Fox Professional Geology, PLLC
310 Cherry Road
Syracuse, New York 13219

19 February 2024

RE: Document Review
Brillo Landfill Site
Town of Victory, Cayuga County, New York
FoxPG Project Number STE-002

Figure 7 – 2021 RI Residential Well Sampling Locations
Source: Figure 8 from TRC (2021)

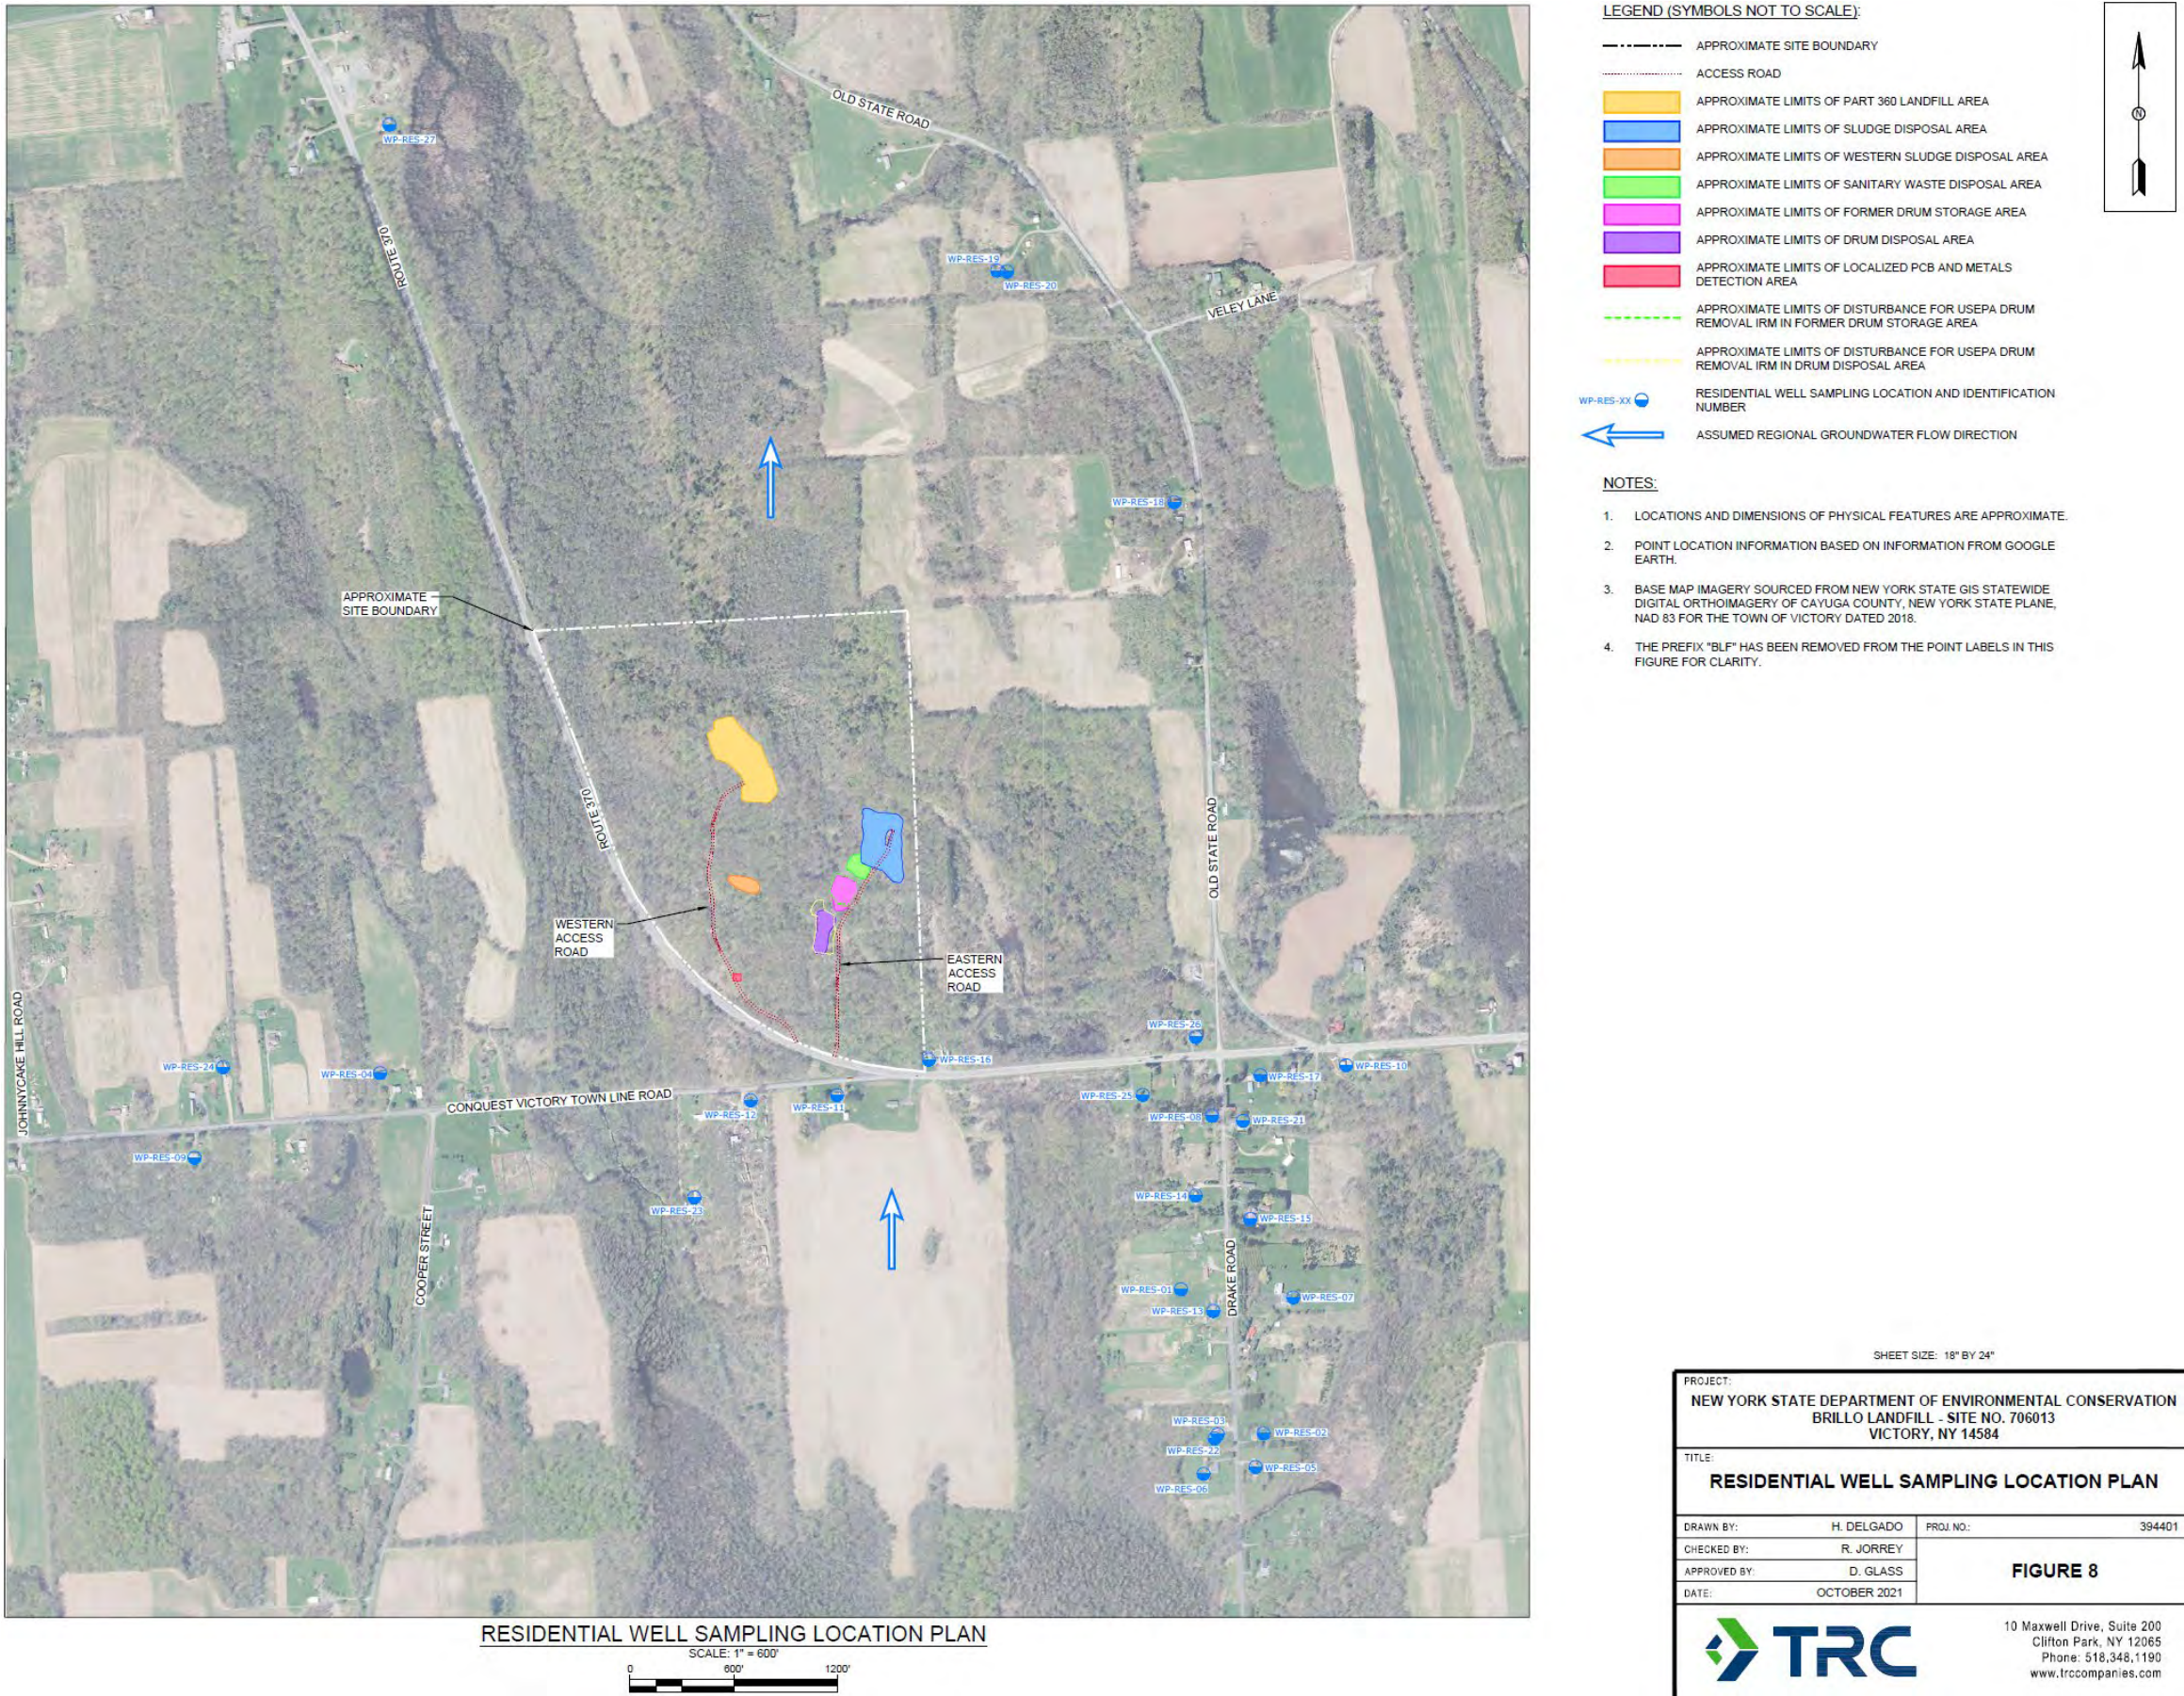
- Figure 7 (Attachment A) shows the locations and designations of all private water supply wells sampled during the RI. TRC indicates that Site-related contaminants were not detected at concentrations above applicable SCGs in water samples collected from off-Site private water wells. While that may have been true at the time their report was finalized (October 2021), NYSDEC subsequently established a human health criterion of 2.7 nanograms per liter (ng/l) for PFOS. PFOS was detected in the residential water well sample designated “BFL-WP-RES-23” at a concentration of 7.6 ng/l, indicating that PFOS was present in that well at a concentration above the current human health criterion. Treat

- Figure 7 also shows an assumed regional groundwater flow direction towards the north. This suggests that most of the residential wells sampled to date may be located in an upgradient direction relative to areas of contamination at the Site. While shallow groundwater flow was measured and assessed during the RI (see Attachment A, Figure 8), deeper intermediate and regional groundwater flow was not measured or assessed during the RI. Assessment of deeper intermediate and regional groundwater flow is required to fully understand potential contaminant fate and transport at sites with significant levels of recalcitrant contamination (e.g., CVOCs, PFAS, metals) because regional groundwater flow and transport of contaminants distances of several miles or more is possible at such sites.

Figure 9 – 2021 RI Conceptual Site Model for Sludge Disposal Area
Source: Figure 16B from TRC (2021)

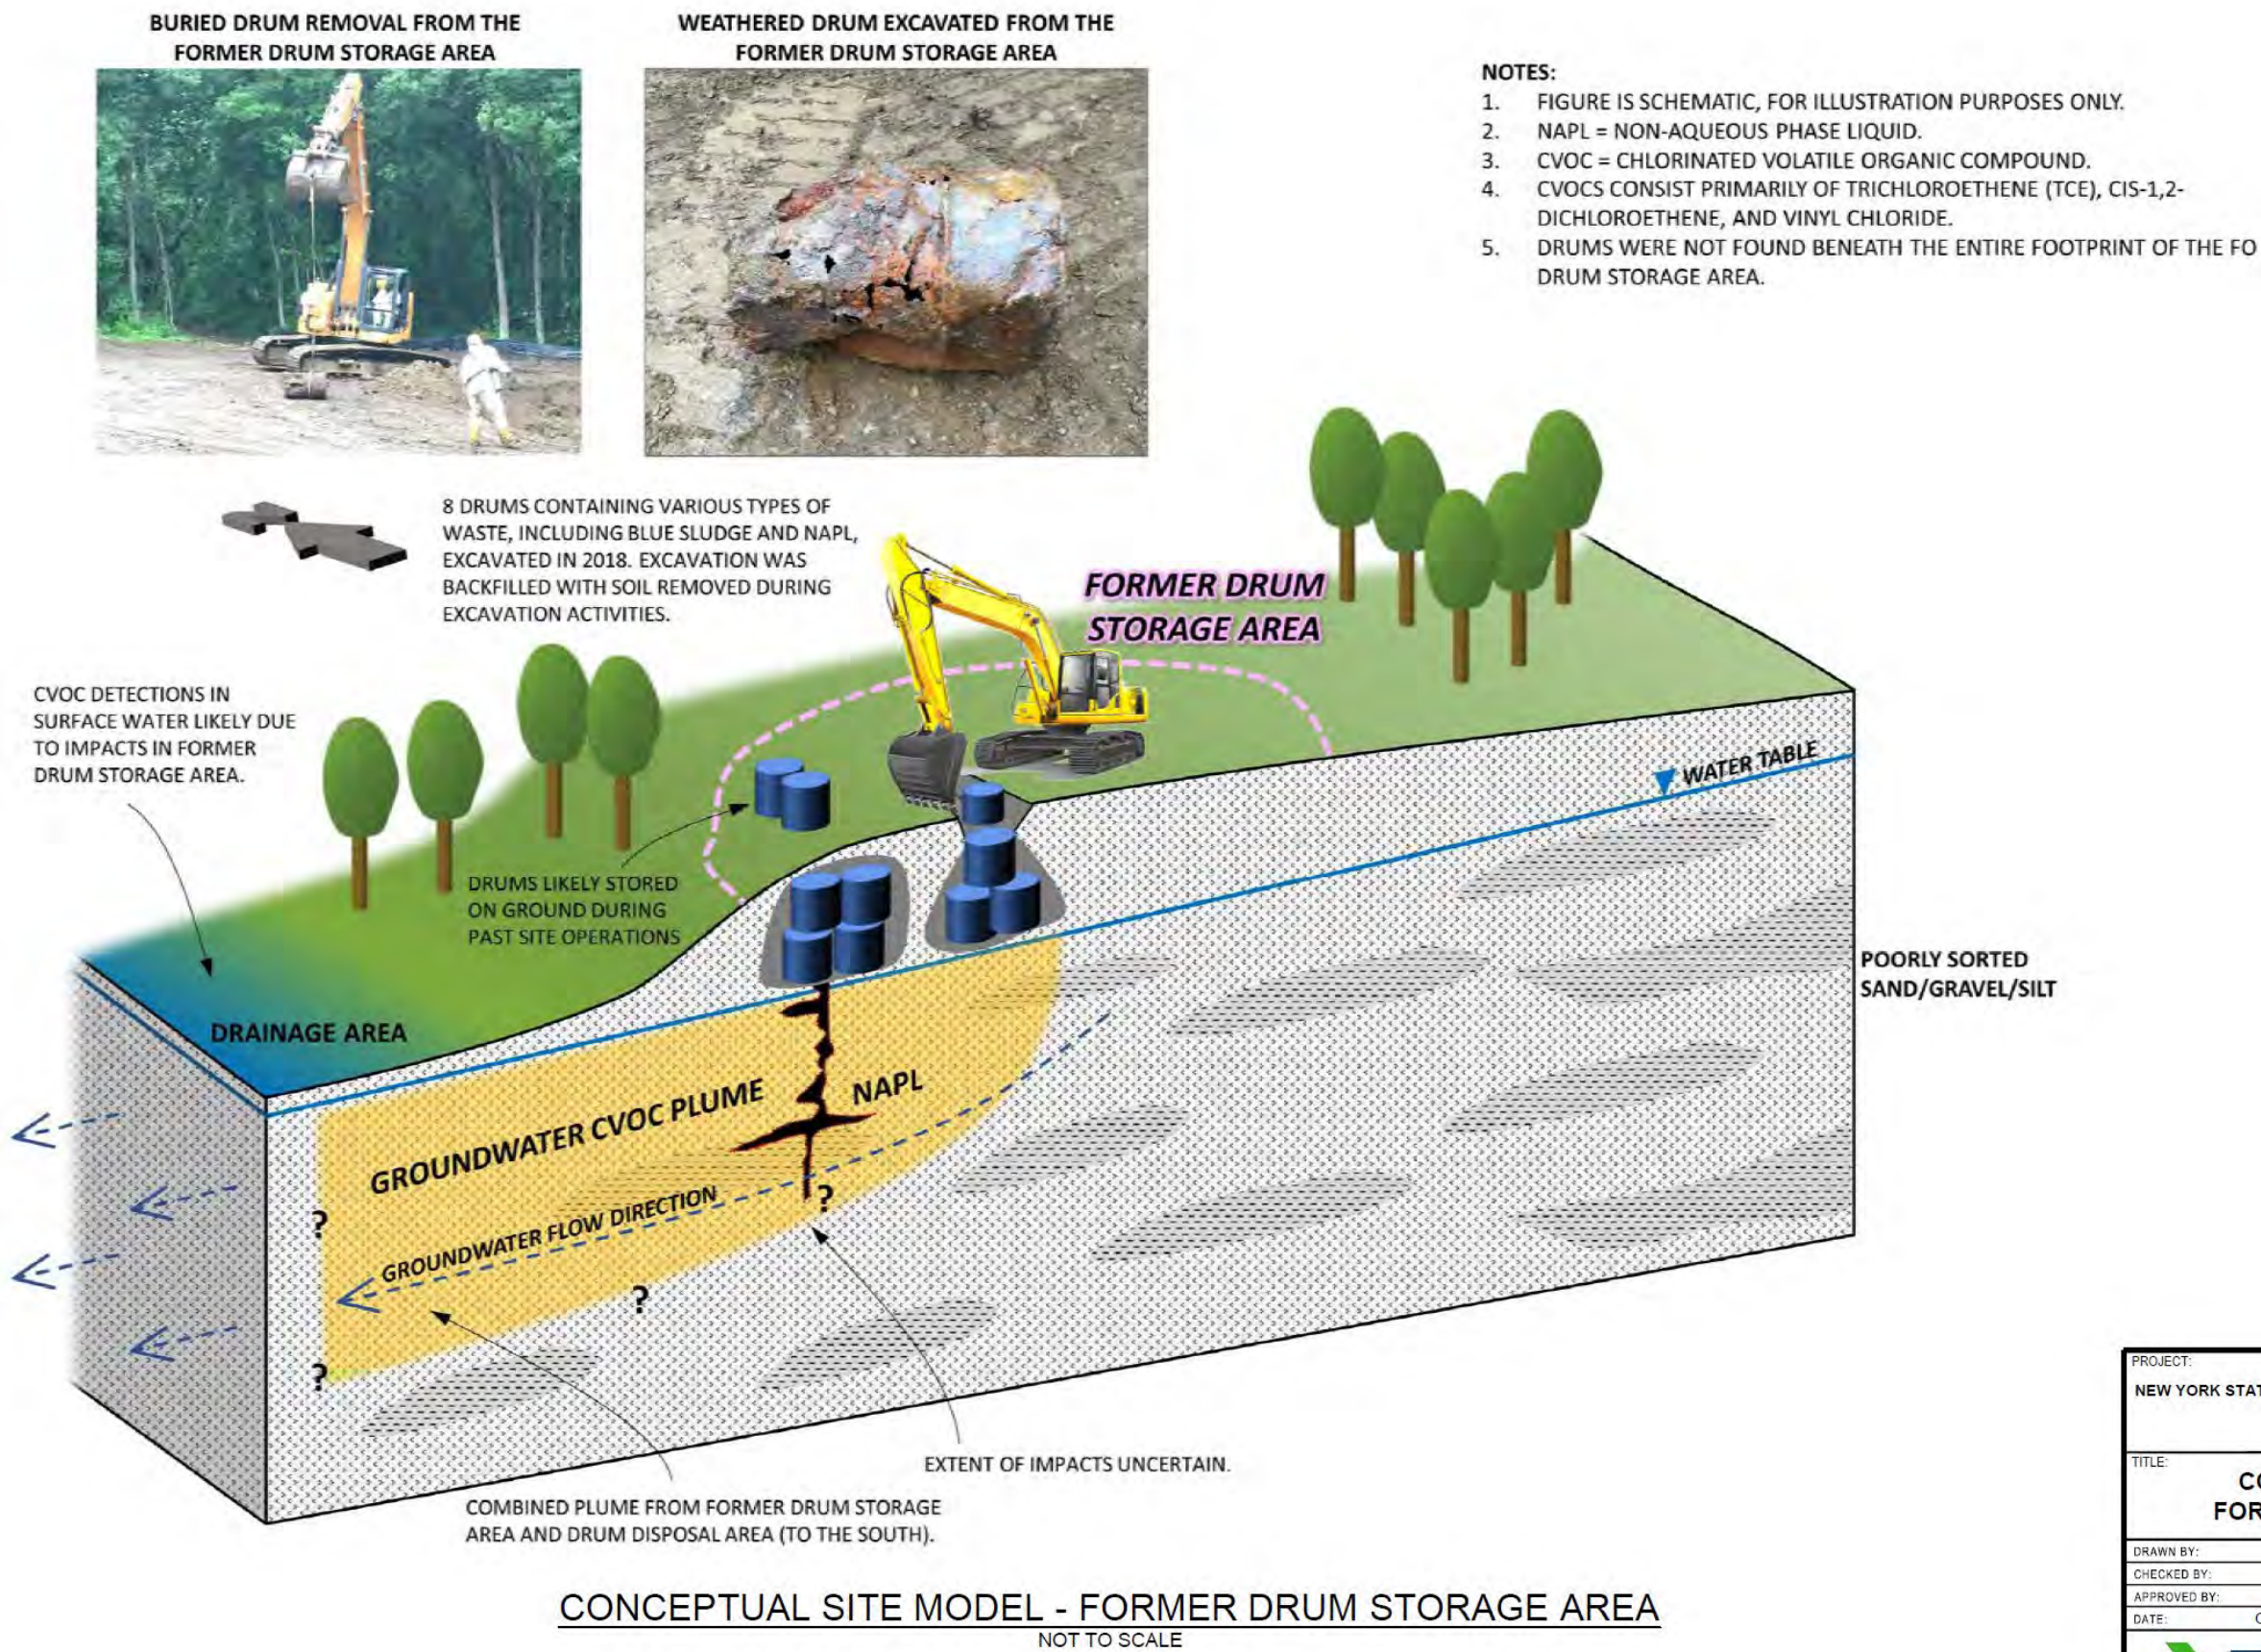
- Figure 9 (Attachment A) shows a Conceptual Site Model (CSM) from the RI Report for the Sludge Disposal Area. The goal of a CSM is to provide a description of relevant site features and the surface and subsurface conditions at the Site to understand the extent of identified contaminants of concern and the risk they pose to receptors. This CSM illustrates the ongoing transport of contaminants from the Sludge Disposal Area into the low lying “Drainage Area”, which is a regulated wetland ecological resource. The blue sludge material is grossly contaminated media as defined by NYSDEC; it also fits the definition of a source area contained in Section 1.3(b)70 of NYSDEC’s DER-10 Technical Guidance for Site Investigation and Remediation (NYSDEC, 2010a). The NYSDEC’s policy on soil cleanup guidance (NYSDEC, 2010b) requires that all sources of contamination are addressed. This NYSDEC policy also states that for sites in the State Superfund Program (i.e., this Site), the goal for the remedial program is to restore the site to pre-disposal conditions, to the extent feasible.
